DEVIATION REQUEST AND DECISION FORM

Project Name : Meadowlake Industrial Park

A deviation from the standards of or in Section 2.2.5.B.1 of the Engineering Criteria Manual (ECM) is requested.

Figure 2
Site Plan

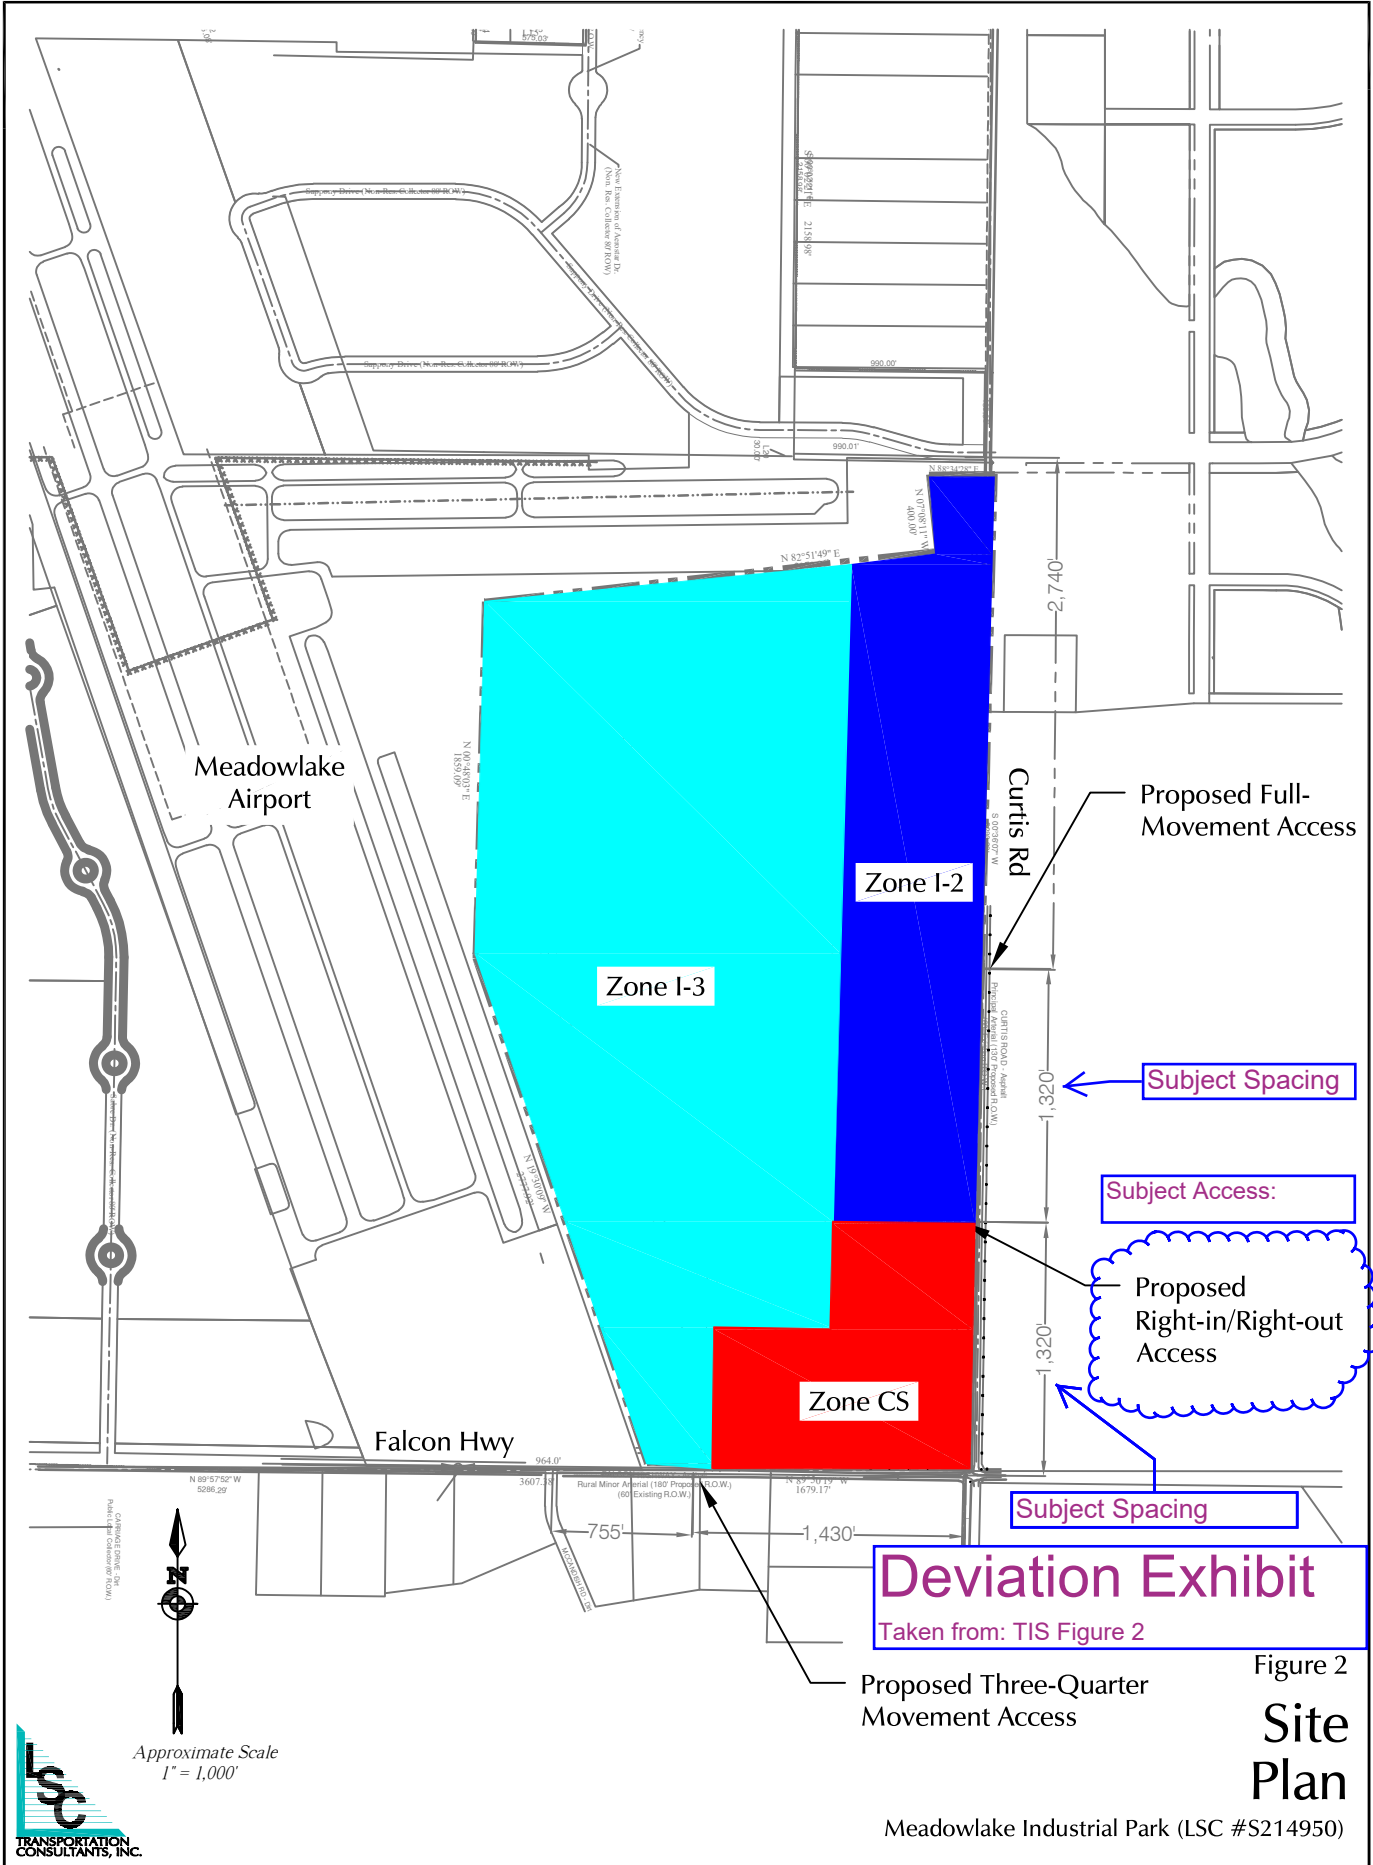
The applicant is requesting approval of a planned public street connection to the west side of Curtis Road ¼ mile north of Falcon Highway. The request is for right-in/right-out intersection with Curtis Road. Please refer to the attached exhibit (Figure 2 from the TIS report).

The proposed alternative is for a right-in/right-out public street intersection with Curtis Road ("access" to the west side of Curtis Road) ¼ mile north of Falcon Highway.

The spacing would be 1,300 feet shorter than the ECM standard for Principal Arterials.

Approval of this deviation request is for the specific intersection spacing and location of the proposed full movement and right-in/right-out access shown on the attached Deviation exhibit.
This approval becomes invalid if either the access location or spacing on future development application differs from the attached deviation exhibit.

This request has been determined to have met the criteria for approval. A deviation from Section 2.2.5.B.1 of the ECM is hereby granted based on the justification provided.
